Date: 07/21/2023 RFB No: **2023-043**

Commodity: North Interceptor Wastewater Improvement Phase 1 Project

Addendum No: 4

\$18,300,000.00

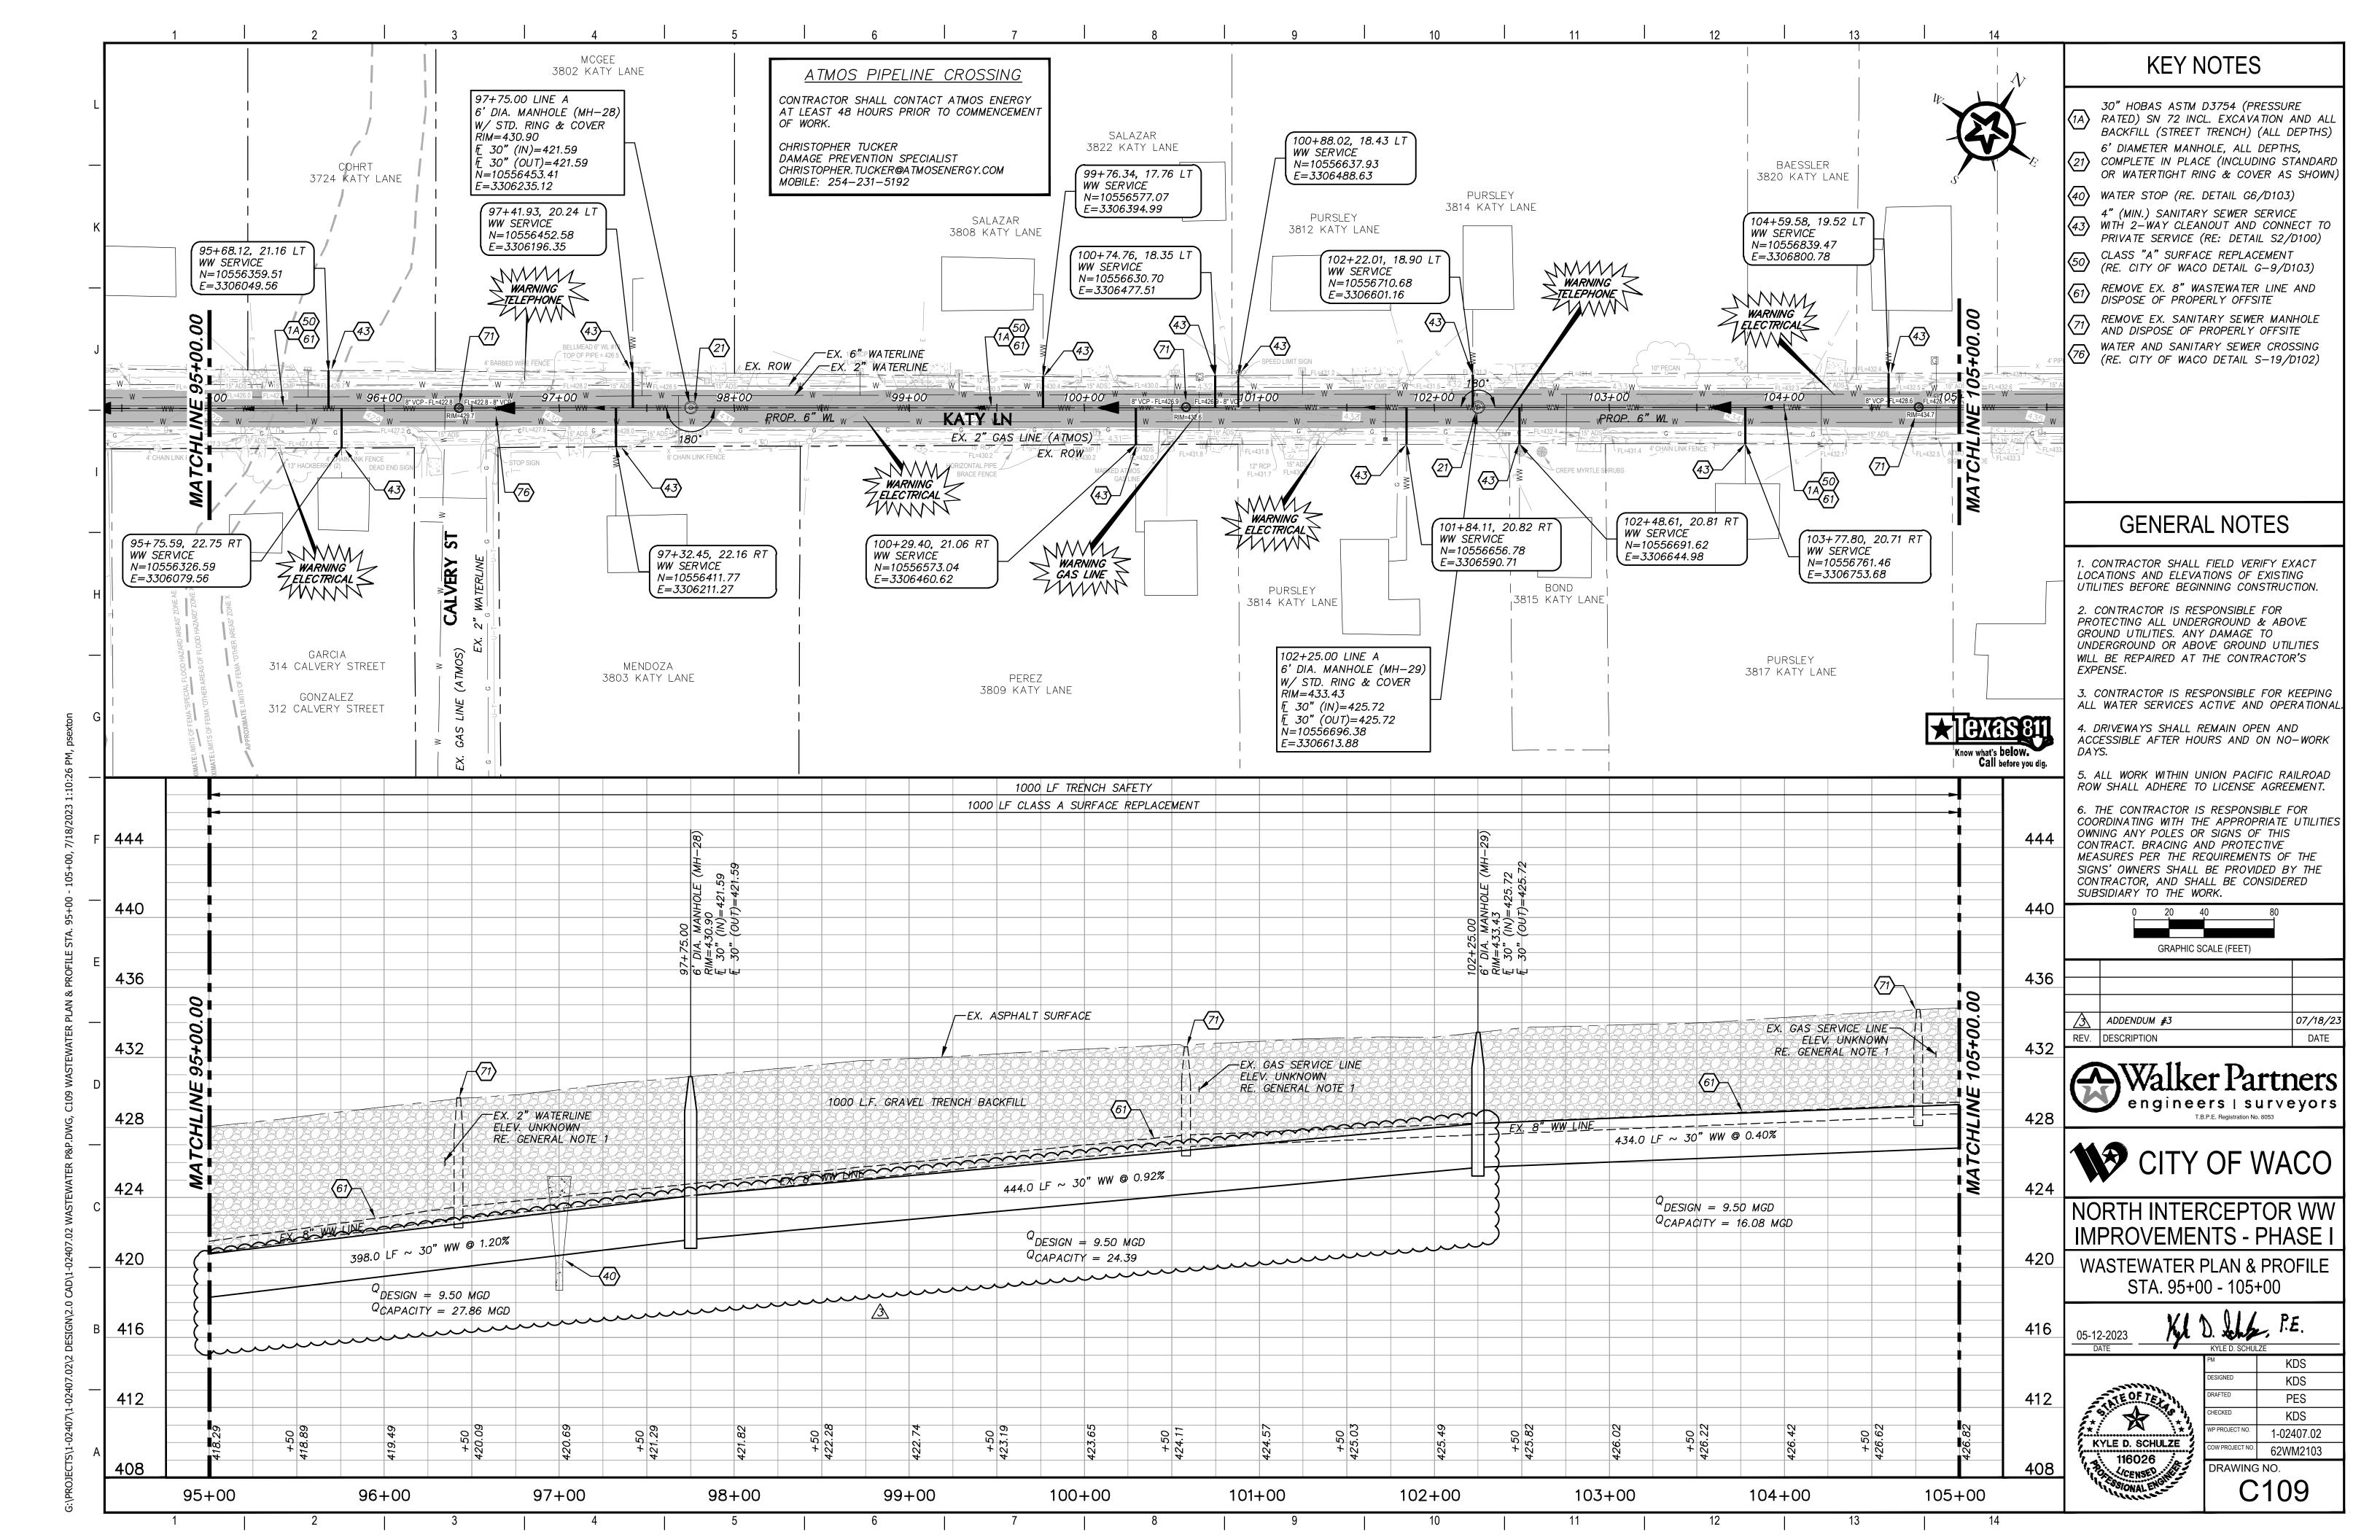
Can we assume that existing force main lines (16" & 8") can be isolated independently to facilitate the tie-over? Meaning, can the 8" force main handle all the flows for a short period of time?

The existing 16" force main at Williams Road is not currently in use. The existing 8" force main is active and conveys all the flow from the lift station. The two existing force mains combine into one 16" force main approximately 1,200 LF west of Williams Road near intersection of Texas Street and Highway 84. The 16" force main west of Texas Street is active and carries all flow from the lift station. City Record Drawings are attached for reference.

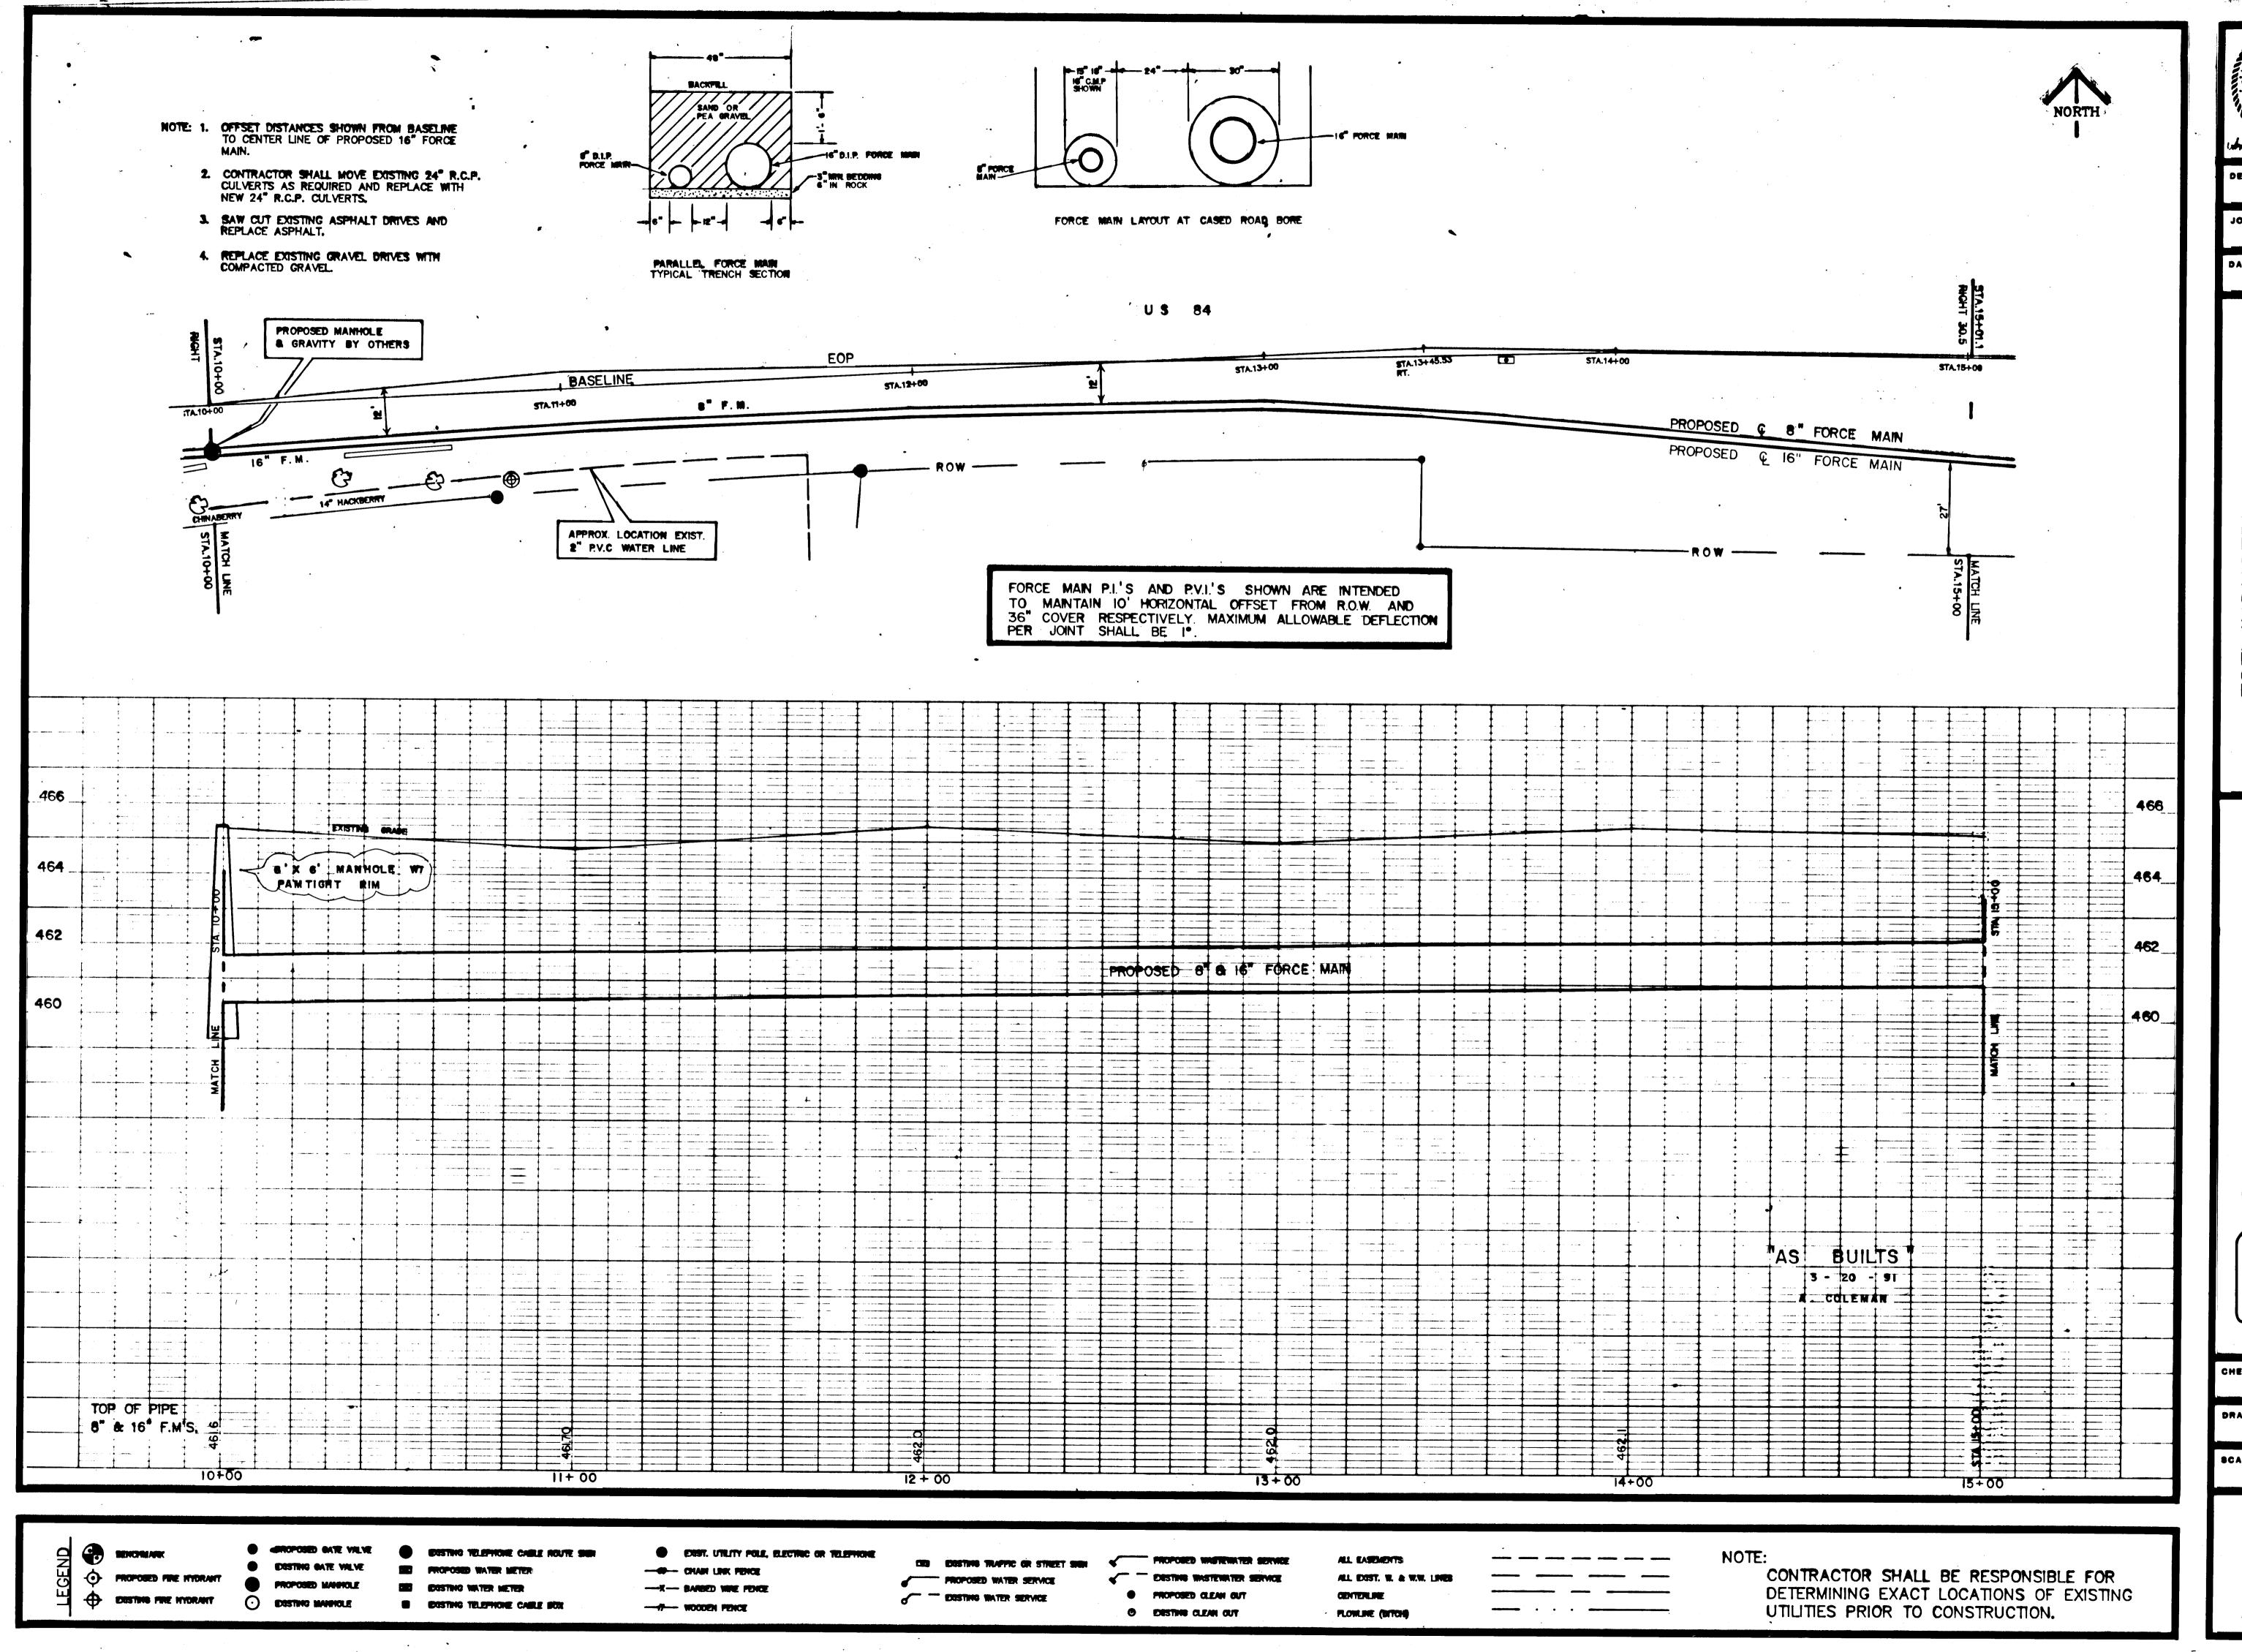
- 1) Replace Sheet C107 with the revised attached Sheet C107
 - a. Profile of 30" wastewater line has been adjusted from Sta. 83+75 to 85+00 and respective flow capacity values were changed accordingly.
- 2) Replace Sheet C108 with the revised attached Sheet C108
 - a. Profile of 30" wastewater line has been adjusted from Sta. 85+00 to 95+00 and respective flow capacity values were changed accordingly.
- 3) Replace Sheet C109 with the revised attached Sheet C109
 - a. Profile of 30" wastewater line has been adjusted from Sta. 95+00 to 102+25 and respective flow capacity values were changed accordingly.
